RIVERSIDE HEALTH SYSTEM 2ND ADDITION

Final Platting
Revised 11-5-98

Re: S/D97-83 -- One Step Final Plat of RIVERSIDE HEALTH SYSTEMS 2ND ADDITION

Re: S/D97-83 -- One Step Final Plat of RIVERSIDE HEALTH SYSTEMS 2ND ADDITION

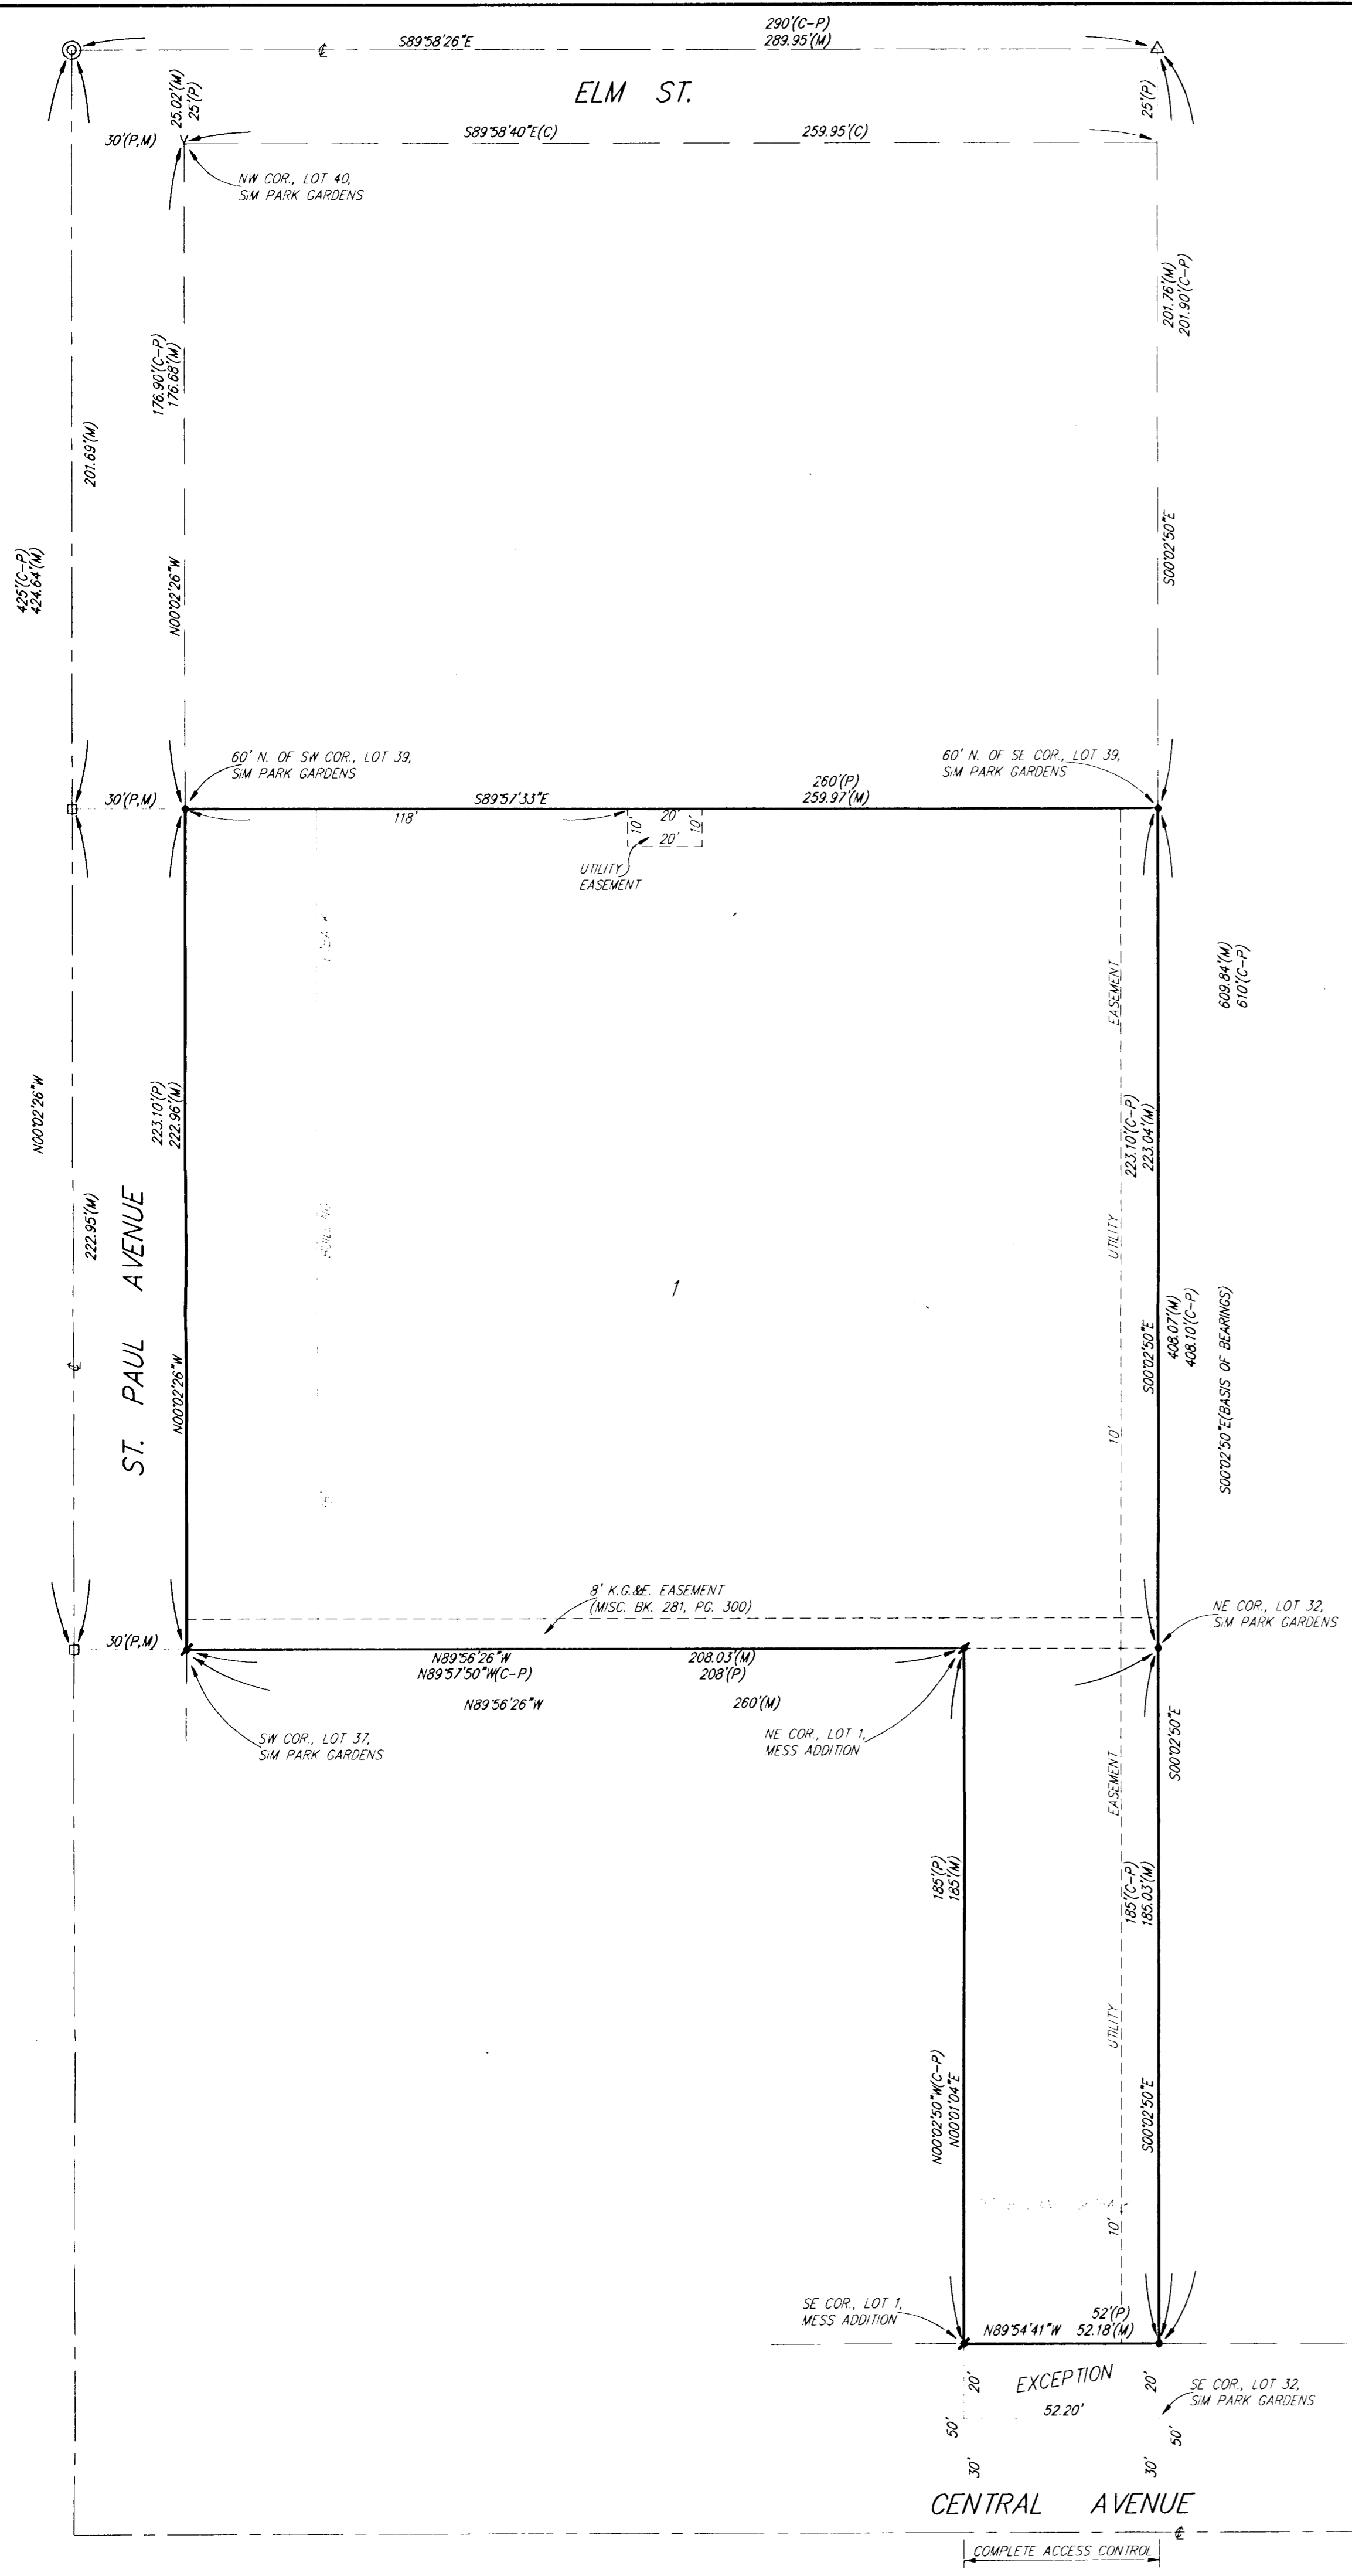
- C. A temporary easement will need to be established by separate instrument for the existing sanitary sewer line that is intended to be abandoned, unless the sewer line is abandoned before the plat is recorded. **City Engineering requires a guarantee for the abandonment of the sewer line.**

- D. Traffic Engineering needs to indicate the need, if any, for access controls. **Traffic Engineering recommends complete access control along Central.**

- F. The Subdivision Regulations require a 35-foot building setback from perimeter streets for commercial lots, which should be denoted on the final plat.

- G. As an office lot adjacent to a non-arterial street, the plat should designate a sidewalk along St. Paul Avenue, in accordance with the sidewalk ordinance.

- H. For portions of the site with existing tree rows that may be impacted by the installation of utilities, it is recommended that overly wide utility easements (30 foot) be platted in order to allow for the installation of the utilities without damage to such tree rows.

- I. The distance from the property to the centerline of Central Avenue should be denoted on the plat.
- J. The applicant shall install or guarantee the installation of all utilities and facilities which are applicable and described in Article 8 of the MAPC Subdivision Regulations. (Water service and fire hydrants required by Article 8 for fire protection shall be as per the direction and approval of the Chief of the Fire Department.)

- P. The representatives from the utility companies should be prepared to comment on the need for any additional utility easements to be platted on this property. **The Southwestern Bell representative requests additional easements as denoted on the attached plat.**
